A/NE-LYT/826
HONG KONG SAR
PLAN

A/NE-LYT/826 FLOOR PLAN

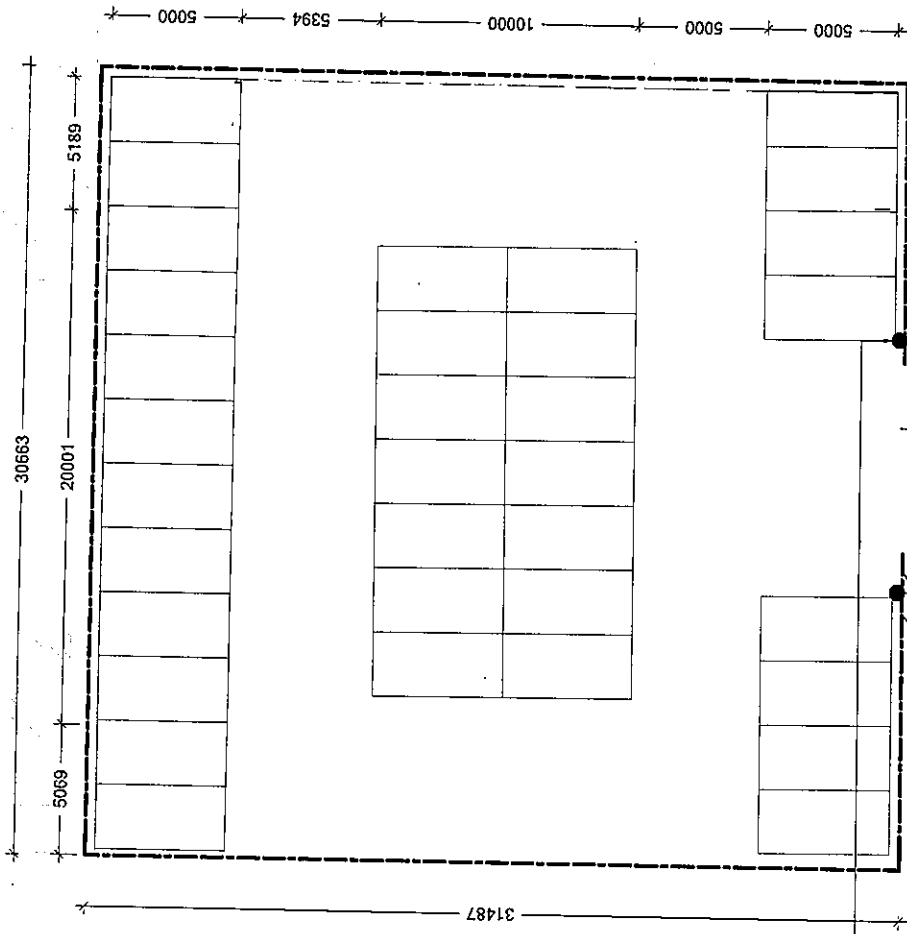
- TURN RIGHT ONLY SIGN.
(DEPT. COMMENT #2)
- TRAFFIC SAFETY MIRROR TO BE INSTALLED.
(DEPT. COMMENT #F)
- RIGHT-OUT EXIT TO SHA TAU KOK RD.
(DEPT. COMMENT #2)
- EXISTING GATE TO BE REMOVED.
(DEPT. COMMENT #E)
- ENTRANCE AND EXIT MANEUVERING PATH.
SEE TYPICAL TURNING RADIUS.
(DEPT. COMMENT #D)
- LEFT-IN ENTRANCE FROM HAI WING RD.
(DEPT. COMMENT #2)
